UNITED STATES
NUCLEAR REGULATORY COMMISSION
WASHINGTON, D. C. 20555

In the Matter of
FLORIDA POWER & LIGHT COMPANY
(St. Lucie Plant, Unit No. 1)
Docket No. 50-335-01A; ASLRP No. 88-560-01-LA

The NRC staff (Staff) has discovered two areas of its proposed "Findings of Fact" (findings) filed in this proceeding on March 17, 1989, which it believes require clarification and correction. These are as follows:

Boroflex Panel in Region I

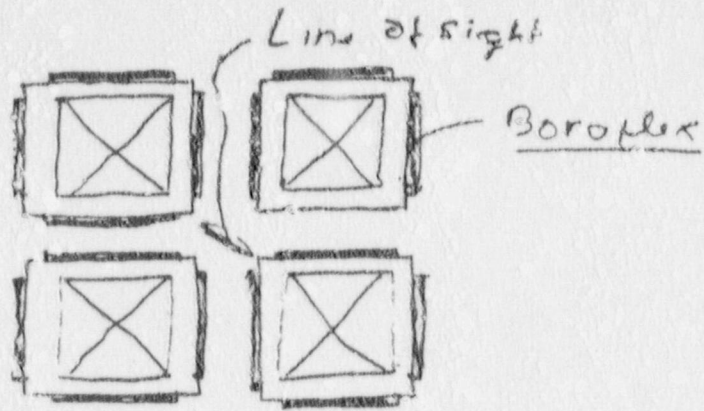
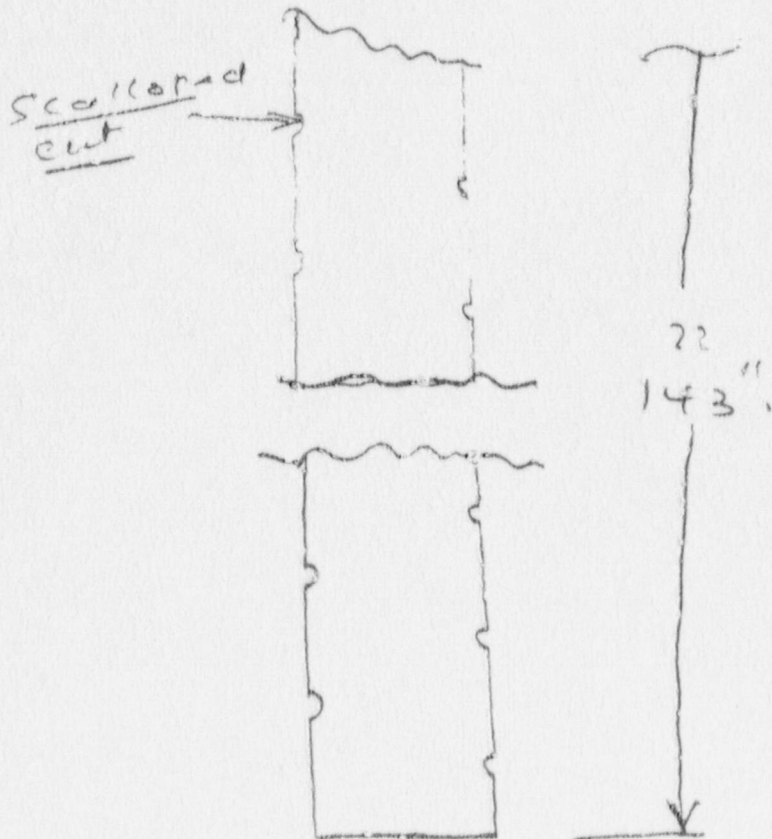
The Staff inadvertently used the number "6" in its findings because it was focusing on the fact that the Boraflex sheets in region one have scallops or cut outs on each side. Each side has the scallop or cut out twelve inches apart. However, the scallops or cut outs are not lined up directly on both sides of the Boraflex sheets. They are offset by six inches. (See, for example, Exhibit 10-Boraflex Panel in Region I, copy attached). However, the use of the number "6" in the context of the above-noted findings was, in fact, incorrect.

findings, the Staff inadvertently stated that Dr. Stanley E. Turner's criticality analyses assumed "one-half inch gaps every 6 inches in the Boraflex in the St. Lucie racks". The number "6" should read "12" in all three of the above cited places in the findings. (See Turner on Contentions 3 and 6, ff Tr. 110 at 19 (fni)).
